**1.3 1494-1496 NORTH ROAD, CLAYTON
USE AND DEVELOPMENT OF THE LAND WITH A SIX (6) STOREY BUILDING FOR
THE PURPOSES OF STUDENT ACCOMMODATION
(TPA/51520)**

The reason for presenting this report to Council is the proposed development cost of \$10 Million.

1494-1496 North Road, Clayton - Use And Development Of The Land With A Six (6) Storey Building For The Purposes Of Student Accommodation

Figure 2 – Rear setbacks

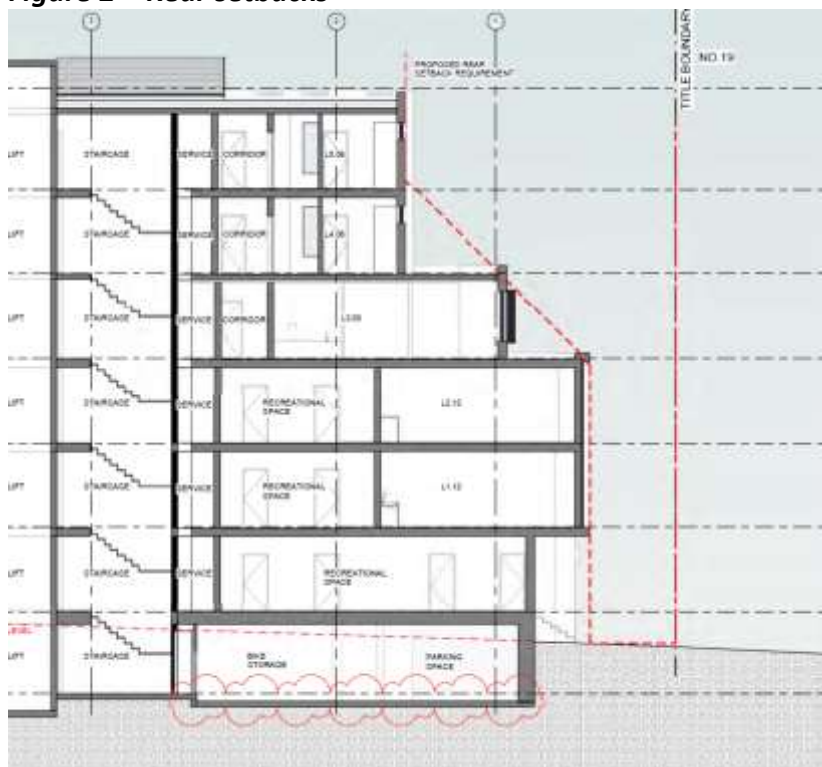
The Clayton Activity Centre Precinct Plan seeks for rear setbacks for any development on this land to be 3 metres up to a height of 9.9 metres, plus 1 metre additional setback for every metre of height over 9.9 metres up to 16.5 metres. This differs from the setback variation prescribed in Schedule 3 of the Residential Growth Zone. The proposal meets this requirement as shown on the sectional diagram below, provided by the applicant (with the red dotted line showing the setback requirements of the adopted Precinct Plan).
